ADDENDUM NO. 01

24 September 2020

AMENDMENTS TO BIDDING DOCUMENTS

Supply of Labor and Materials for the Expansion and Rehabilitation of the Distribution and Service Lines and Appurtenances of Various Barangays in Calamba City Laguna (CWD 30-2020)

V. SECTION VII. DRAWINGS – Various Drawings

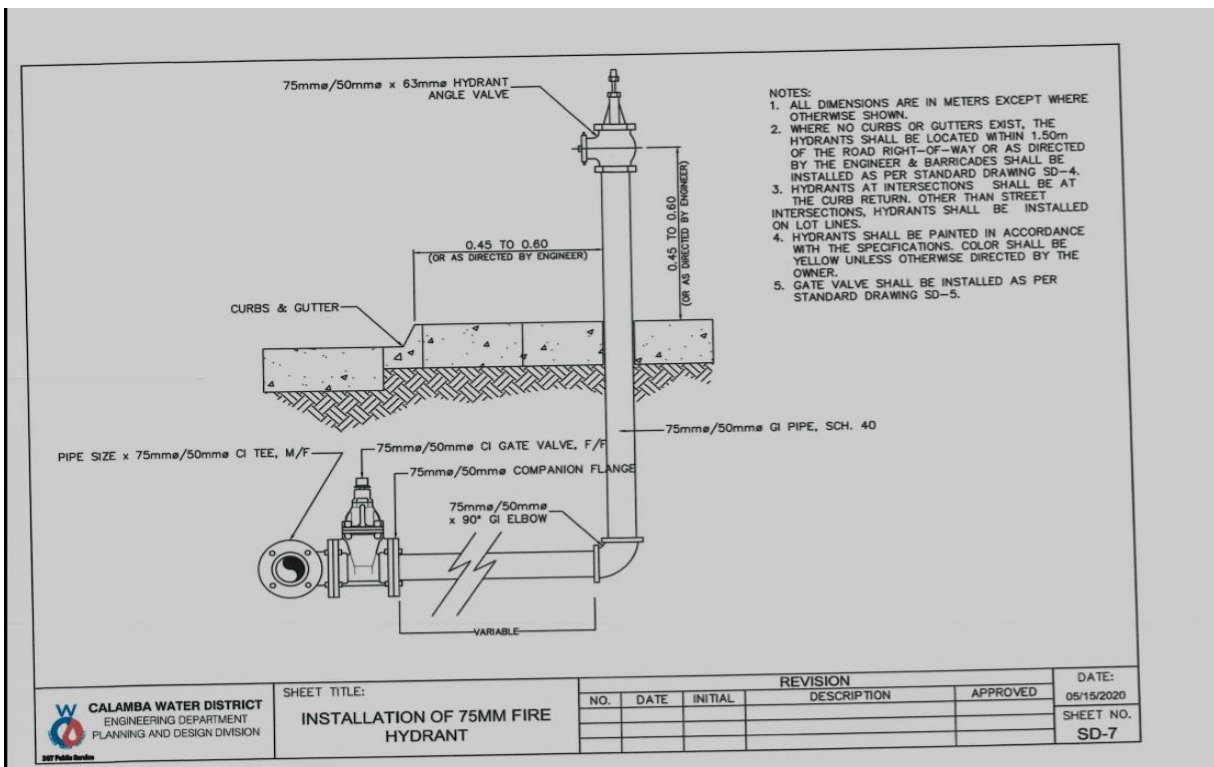
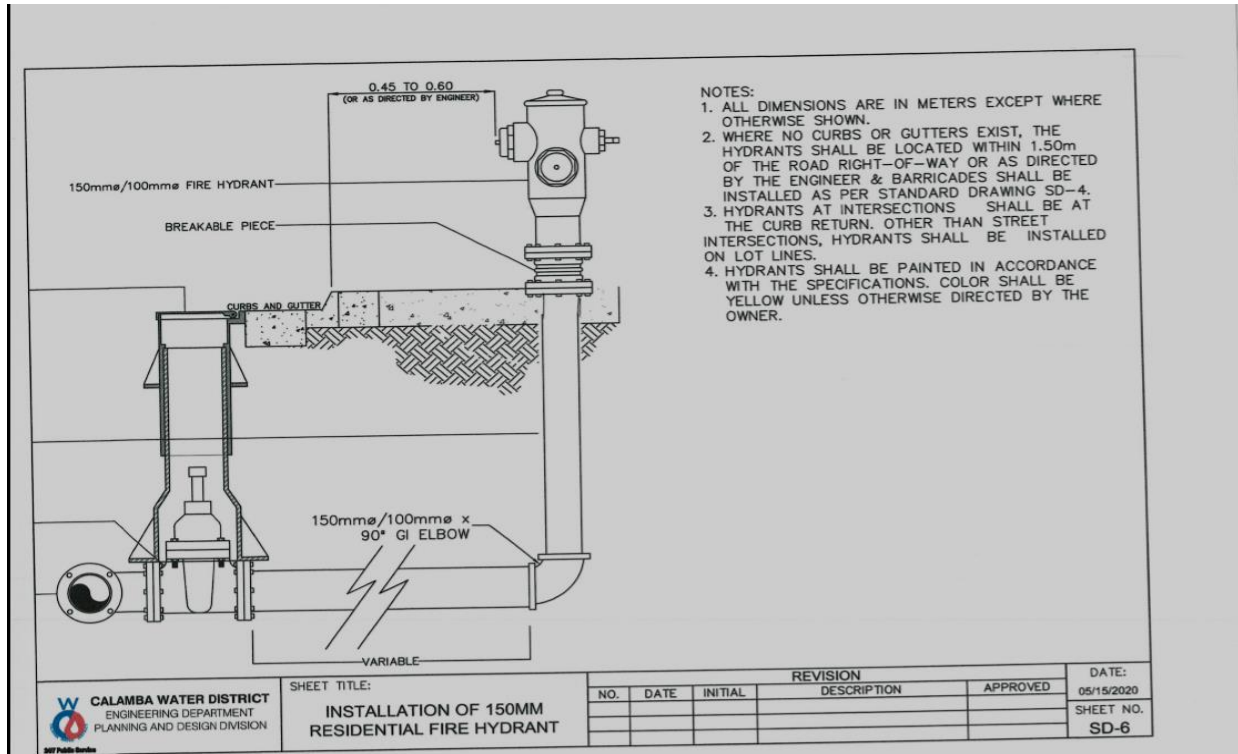
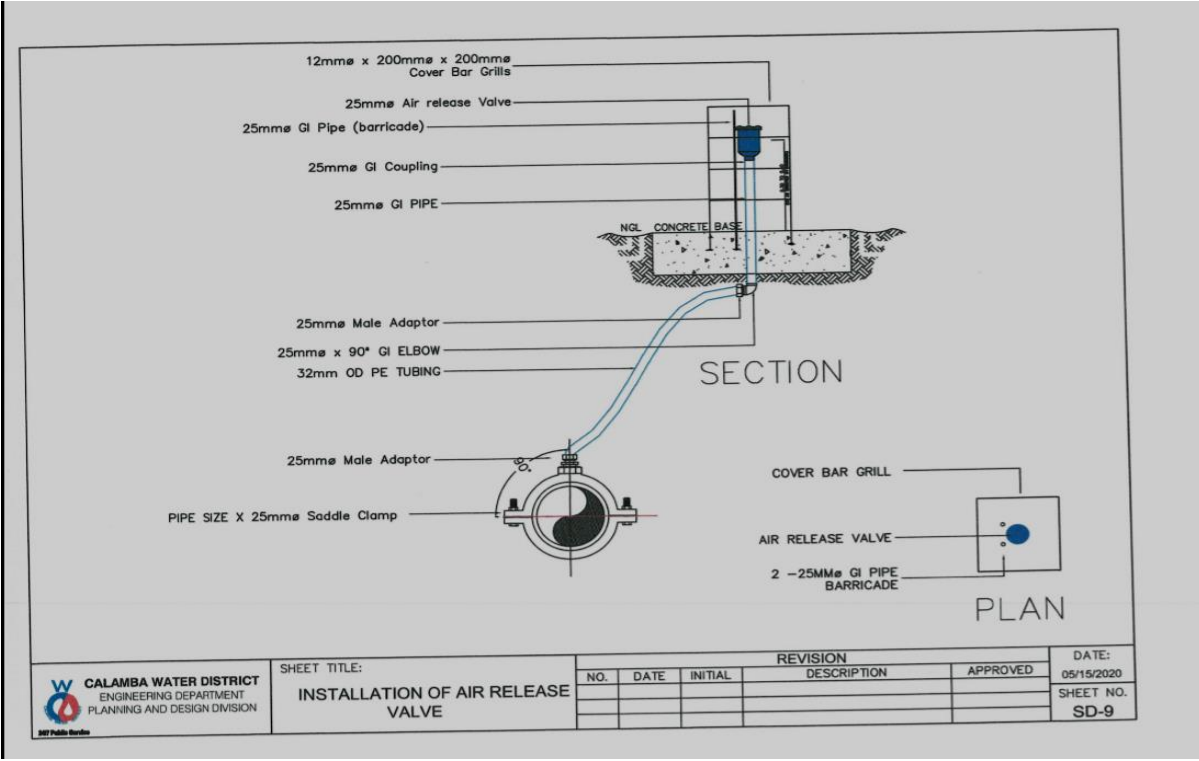
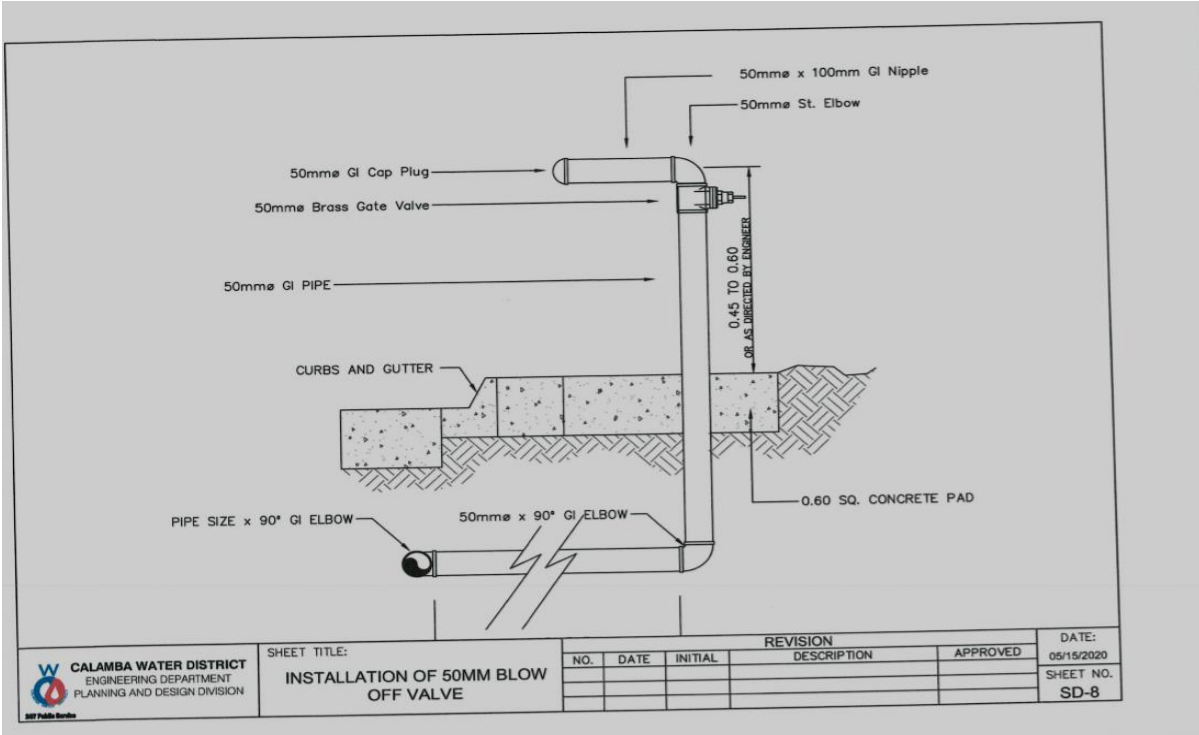
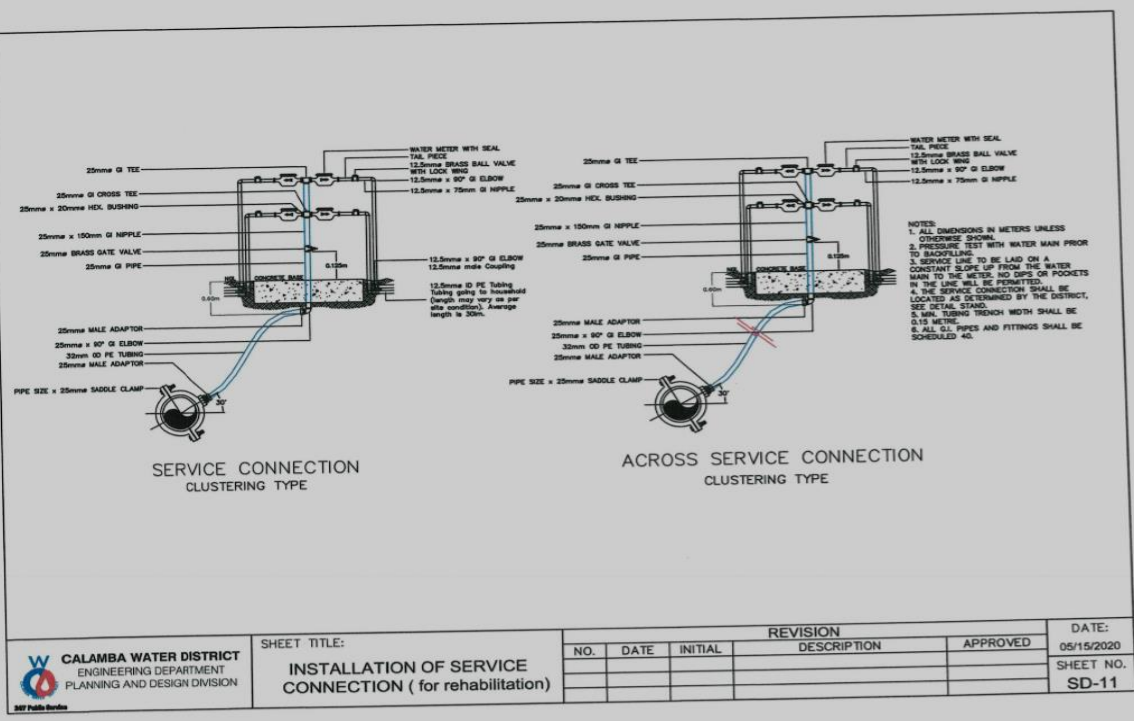
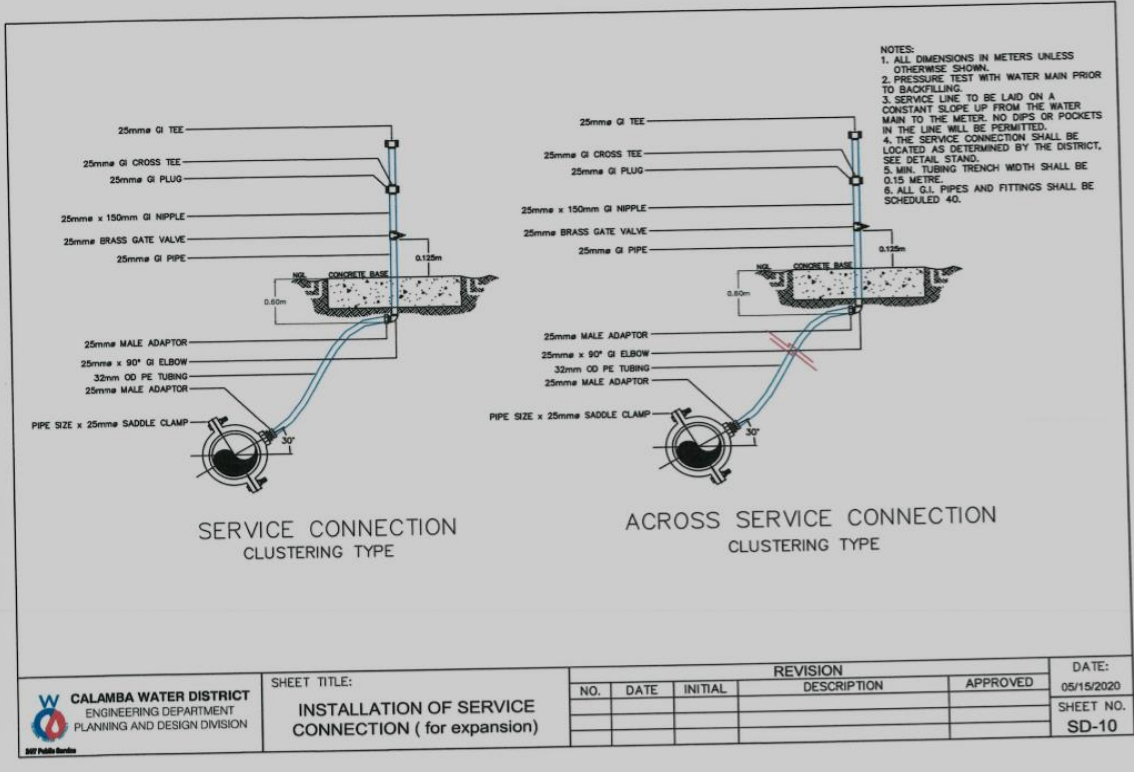
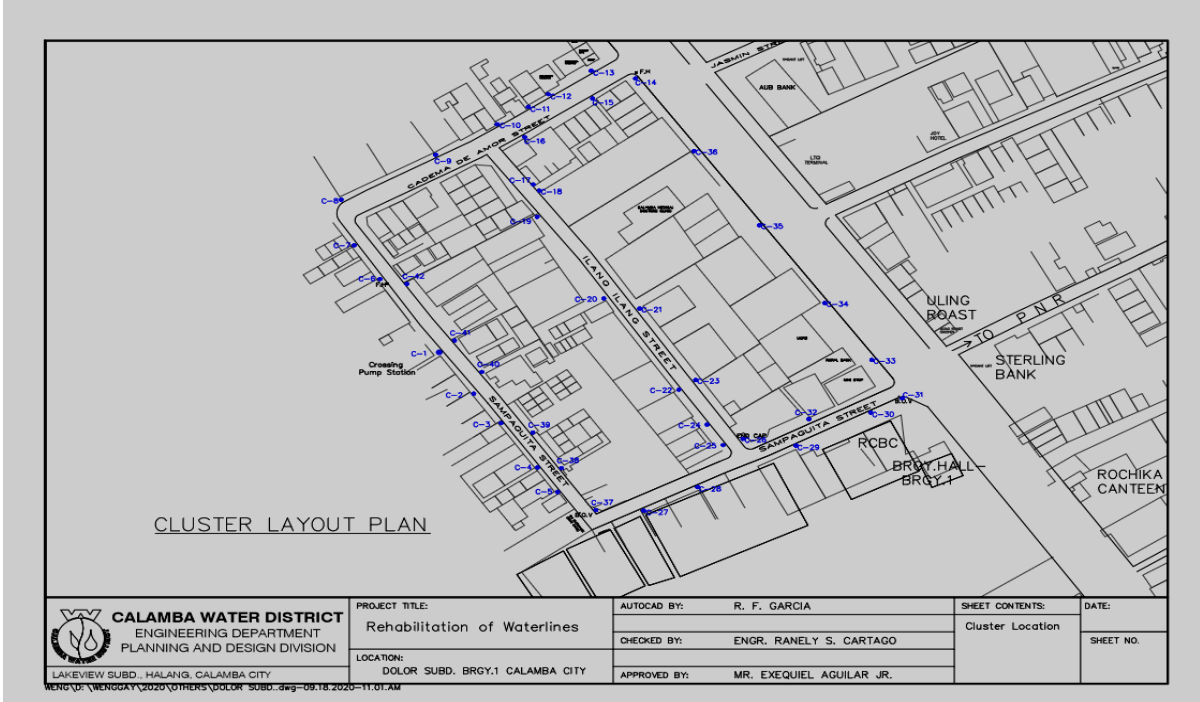
Under **Section I. Invitation to Bid - Paragraphs 2, 5 and 7, Section III. Bid Data Sheet – Clause 17.1, 18.2, 21, and 24.1, Section V. Special Conditions of Contract – Clause 1.17 and 51.1, SECTION VI. Specifications, and Section VII. Drawings – Various Drawings** thereof should be read as follows:
